Access Compliance Report

Public Rights-of-Way

Intersection ID: 10027231	Main Street: GIVENS_WY	Cross Street: N/A	Location: NE
ADA ID: 371997BCF7F6	Ramp Type: Perp	Initial Pass/Fail: Fail	Overall Compliance: No
		Severity Score: 30

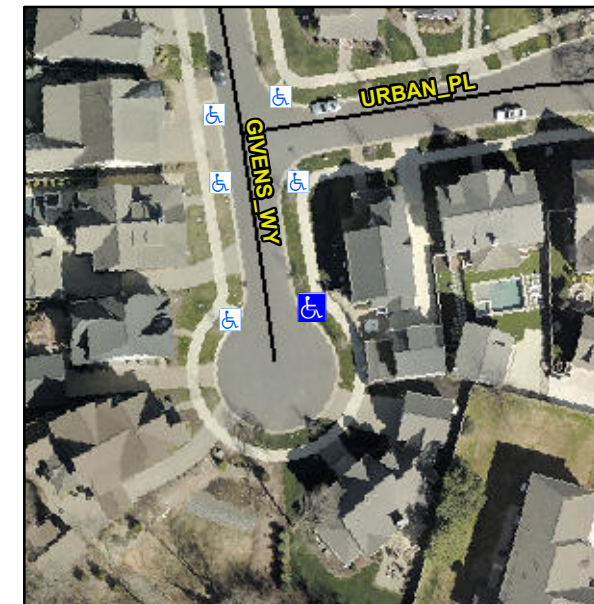
Not Found, R304.5.1, R304.2.2

Compliance	Description	Data	Compliance	Description	Data
N/A	Ramp Length (in)	94.5	No	Ramp Slope (%)	8.6
No	Ramp Width (in)	32.5	Yes	Ramp XSlope (%)	0.1
N/A	Flare Type LT	N/A	N/A	Flare Type RT	N/A
N/A	Flare Slope LT (%)	N/A	N/A	Flare Slope RT (%)	N/A
N/A	Flare Traversable LT?	N/A	N/A	Flare Traversable RT?	N/A
N/A	Landing Length (in)	N/A	N/A	DWS Provided?	N/A
N/A	Landing Width (in)	N/A	N/A	DWS Contrast?	N/A
N/A	Landing Slope (%)	N/A	N/A	DWS Length (in)	N/A
N/A	Landing X Slope (%)	N/A	N/A	DWS Full Width?	N/A
N/A	Landing Curb? (Y/N)	N/A	N/A	DWS Offset (in)	N/A
N/A	Shared Landing?	N/A			
N/A	Gutter Ponding?	N/A	N/A	Gutter Slope (%)	N/A
N/A	Gutter Lip Ht (in)	N/A	N/A	Gutter X Slope (%)	N/A
N/A	Painted X Walk1?	No	N/A	Painted X Walk2?	N/A
	X Walk 1 Direction	To W		X Walk 2 Direction	N/A
N/A	X Walk 1 Width (in)	N/A	N/A	X Walk 2 Width (in)	N/A
	X Walk 1 Slope (%)	2.9		X Walk 2 Slope (%)	N/A
	X Walk 1 X Slope (%)	0.9		X Walk 2 X Slope (%)	N/A

Remove & Replace Entire Ramp.
